**BPDA Design Review Provisos**  
**71 Perrin Street, Roxbury**  
**April 23, 2024**

EXISTING SITE PLAN  
 67 & 71 PERRIN STREET  
 ROXBURY, MA  
 FOR  
 LONGDEN REALTY, LLC  
 CIVIL ENVIRONMENTAL CONSULTANTS  
 8 OAK STREET PEABODY, MA 01960 978-531-1191

PROPOSED SITE PLAN  
 71 PERRIN STREET  
 ROXBURY, MA  
 FOR  
 LONGDEN REALTY, LLC  
 CIVIL ENVIRONMENTAL CONSULTANTS  
 8 OAK STREET PEABODY, MA 01960 978-531-1191

LANDSCAPE PLAN  
67 & 71 PERRIN STREET  
ROXBURY, MA  
FOR  
LONGDEN REALTY, LLC  
CIVIL ENVIRONMENTAL CONSULTANTS  
8 OAK STREET PEABODY, MA 01960 978-531-1191

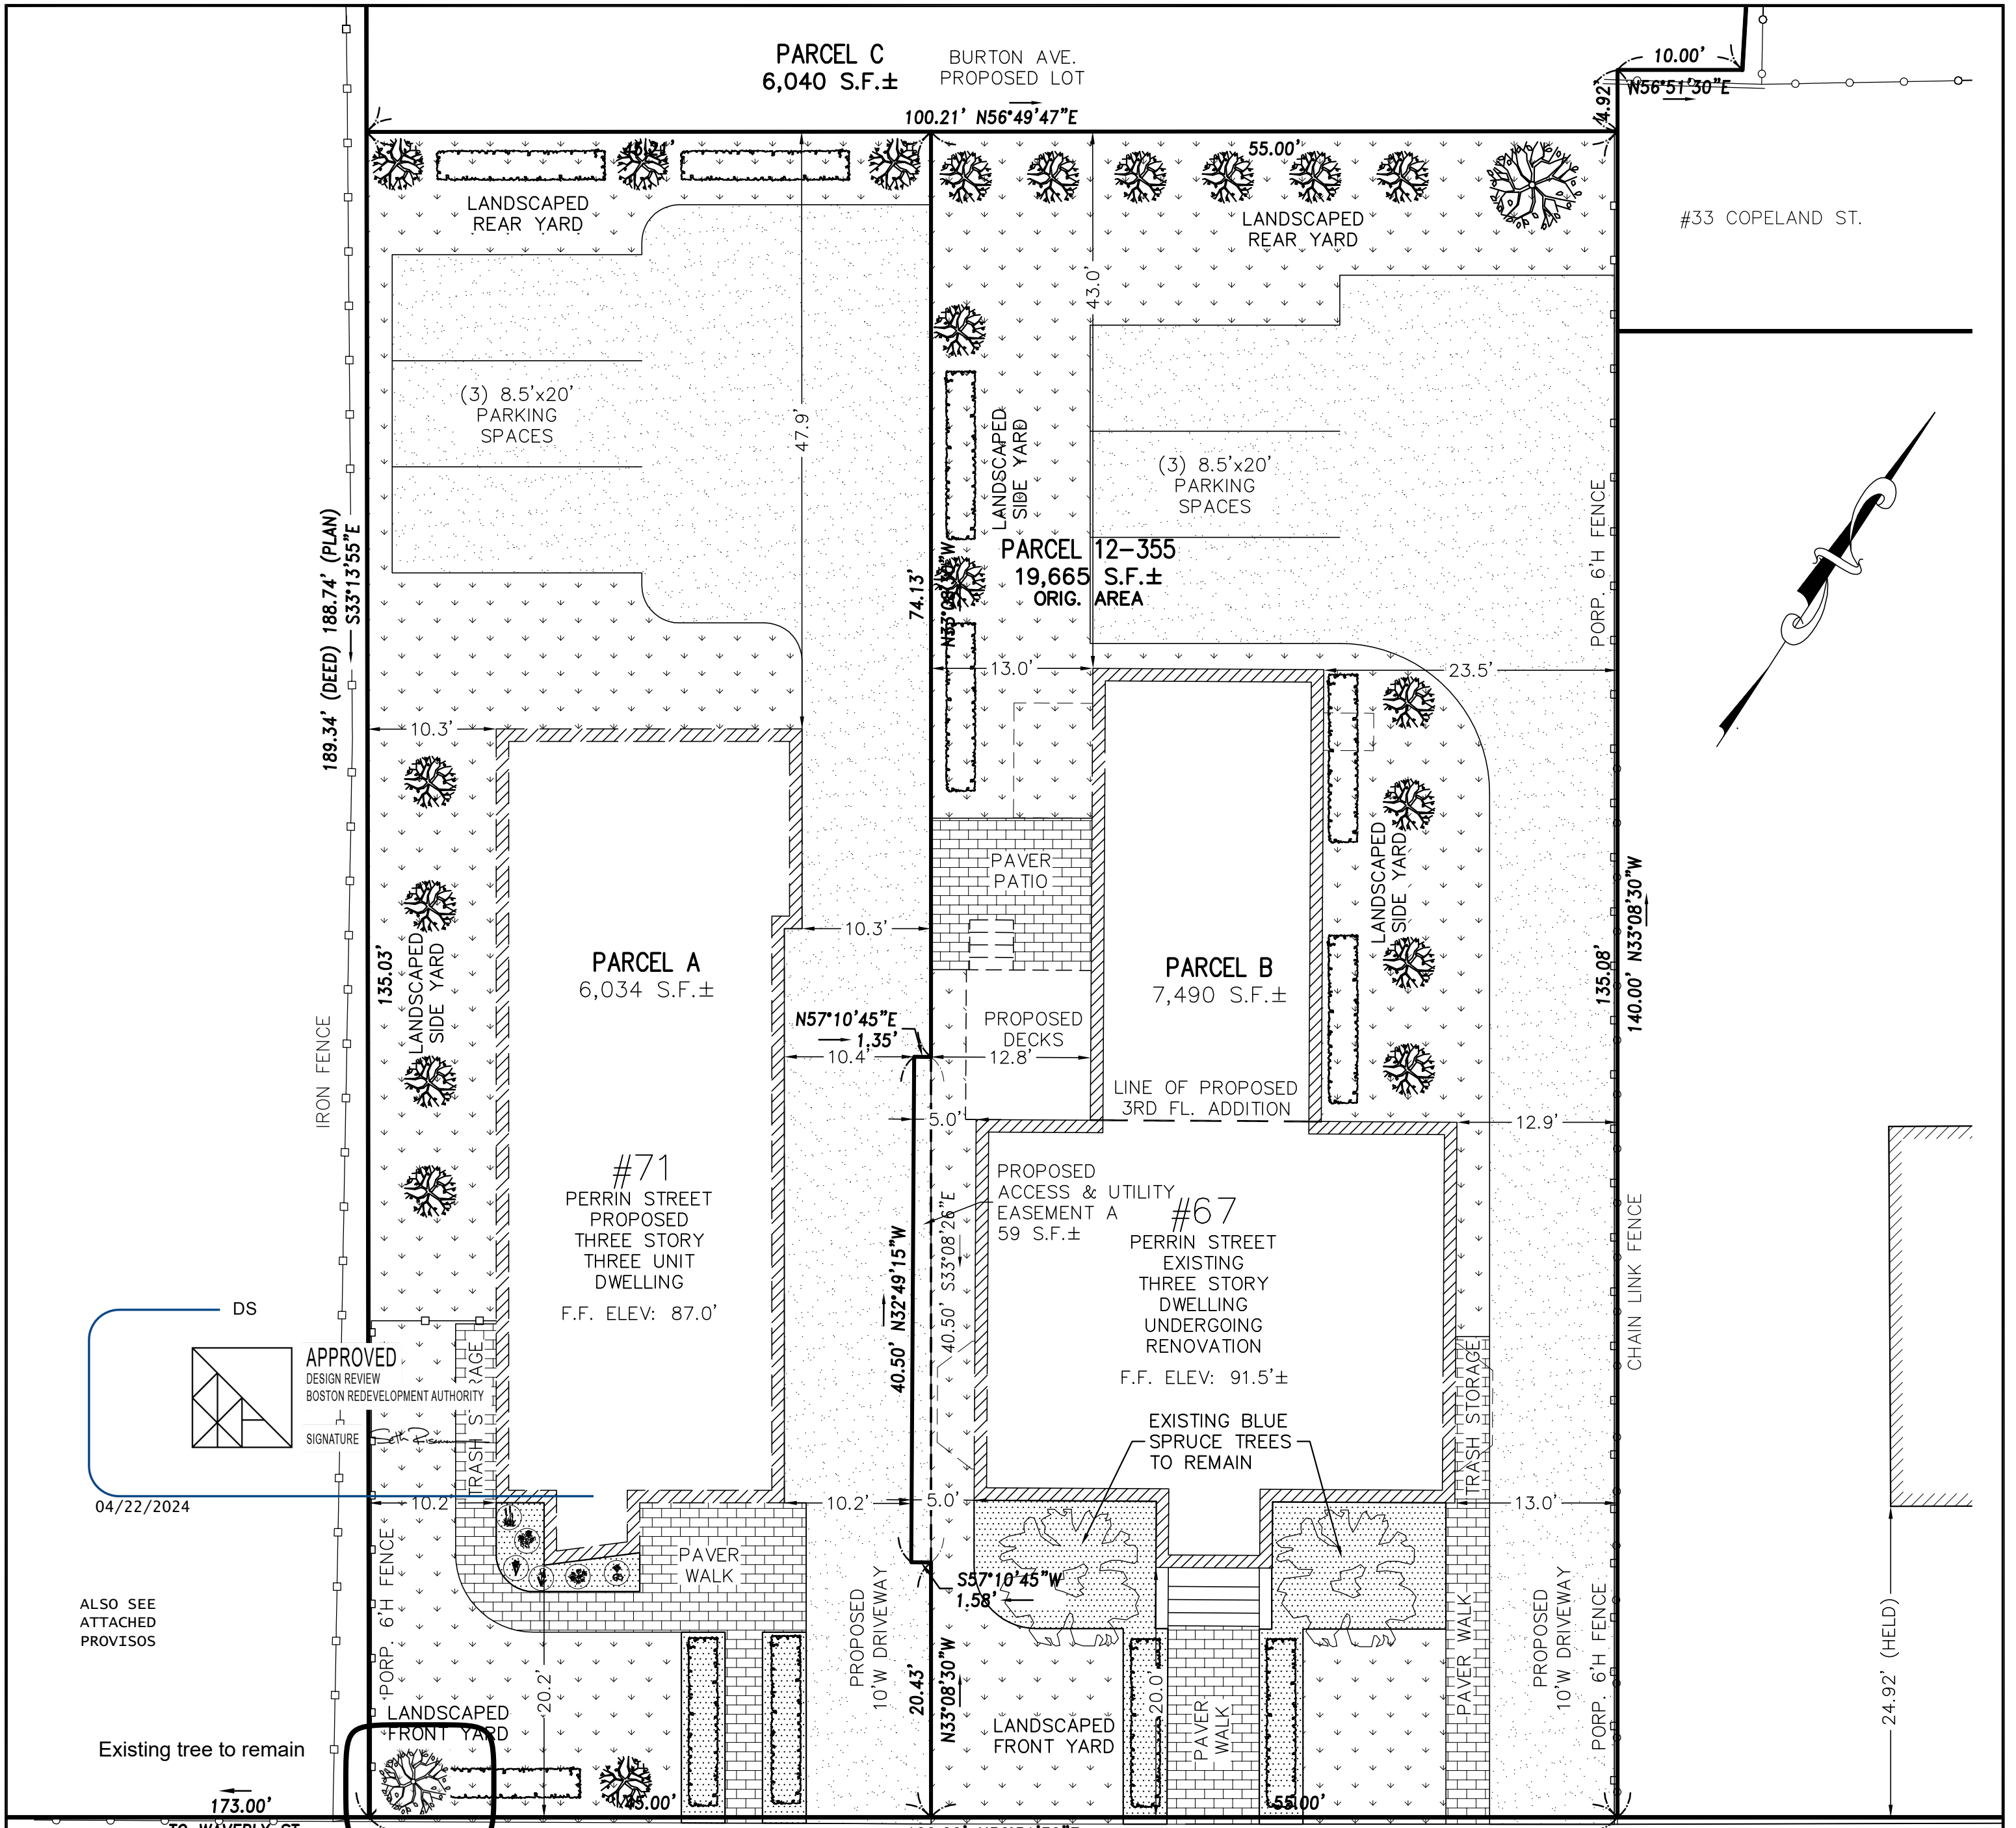
4. All new trees shall have a minimum caliper of 3-inch caliper.
5. Existing trees on the parcel shall be prioritized for preservation when considering lot coverage and building footprint. Mature, healthy and native trees of 6” caliper and above are particularly significant and should be protected to the greatest extent possible. Where impacts are unavoidable and trees must be removed, trees shall be mitigated as specified in the following:

- a. Tree replacement shall be based on 1:1 ratio, based on caliper size of removed trees.
  - b. Replacement trees are to be planted in landscaped areas within the project site, or off-site in the near vicinity (in open pits or other available areas in the general location of the project), with approval by the City.

- c. The Proponent shall be responsible for installation of trees, and maintenance of newly planted trees for at least 24 months after the date of Final Inspection, or issuance of a Certificate of Occupancy.

Existing tree to remain
